Date of Issue: April 23, 2025**SI-18****Project:** Saverino Phase 1
556-560 Essa Road
Barrie ON L4N 9E6**Project No.:** 22-6229**Permit Number:** PMT20-01273**Prime Consultant:** McKnight Charron Limited (MCL) Architects**General Contractor:** Van Horne Construction Limited**Title:** *Plumbing and Drainage Riser Diagram for Suites Revision*

Mechanical:

The following modifications are noted on attached drawings under revision number 12.

DRAWN BY: MB	CHECKED BY: CL	SCALE: 1:100
DATE: APR/2022	PROJECT NUMBER: 22-6229	DRAWING NUMBER: M-107

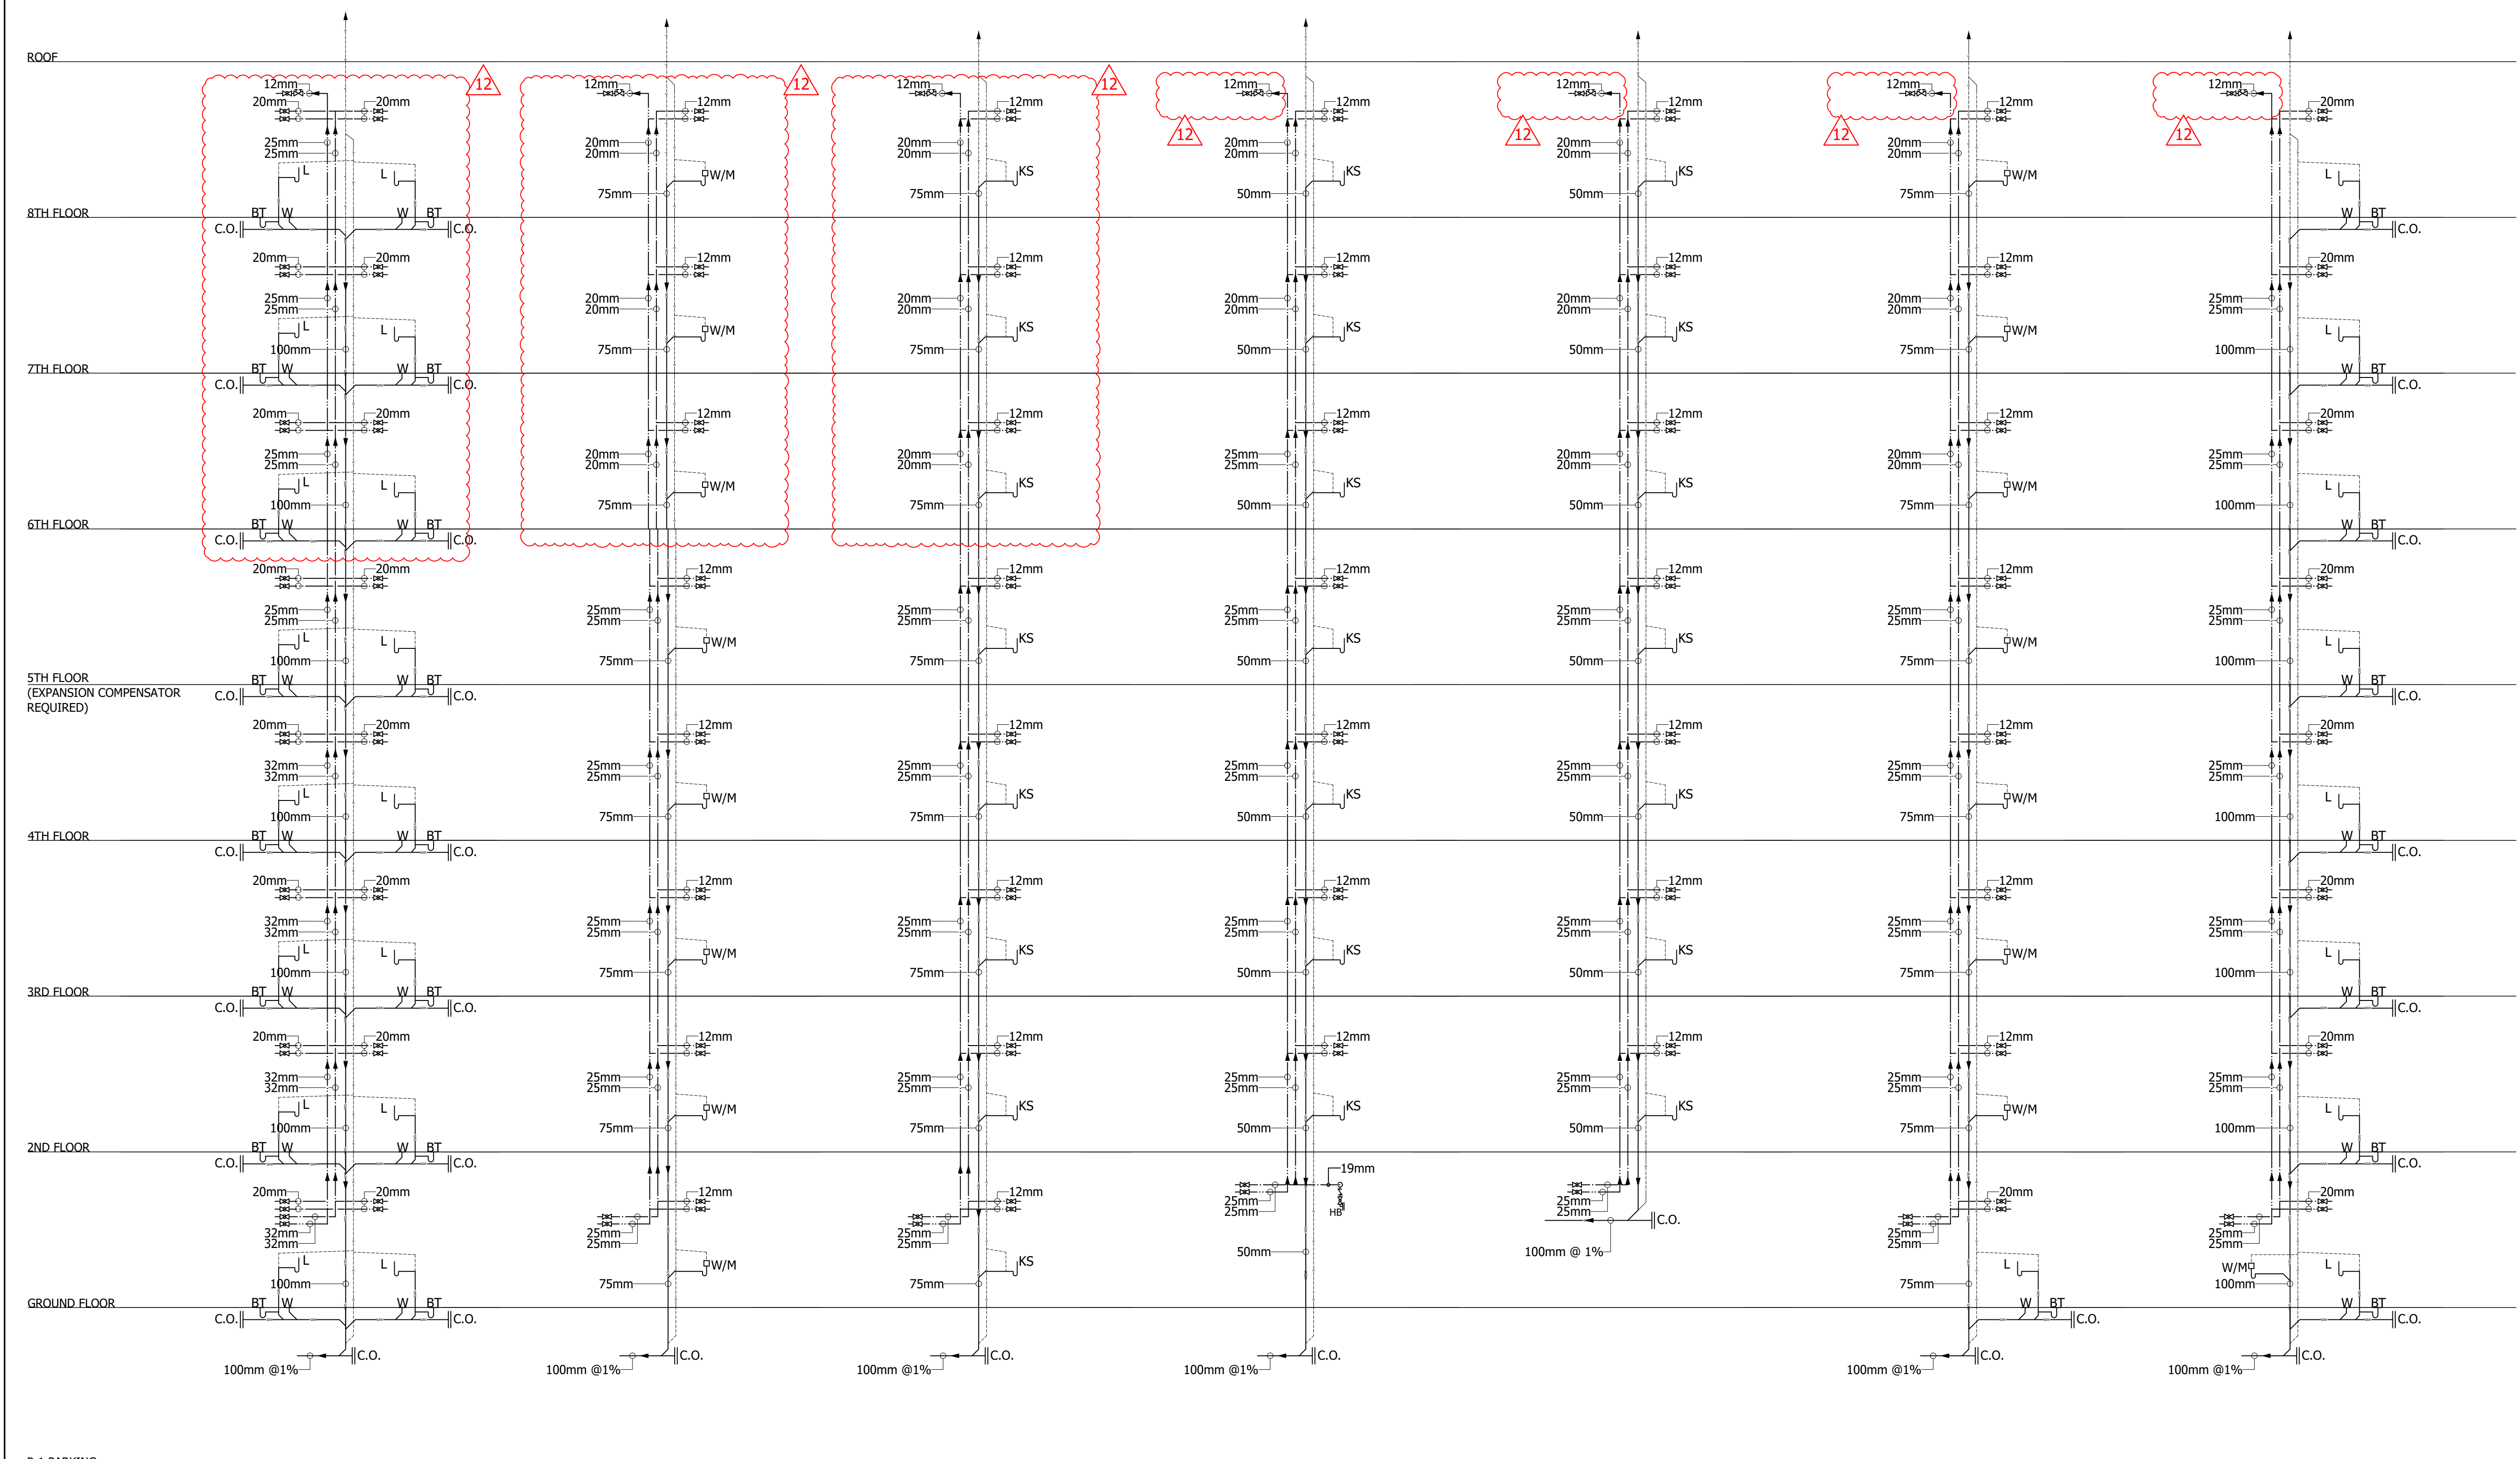
1. Revise plumbing risers and stacks (PD-1 to PD-40) fixture connections as per changes of suites layout (G/F, 7/F and 8/F), change in pipe sizes and add tee-off for 7/F & 8/F suites.
2. Joint domestic hot water recirc. pipes from risers on 8/F instead of 7/F.
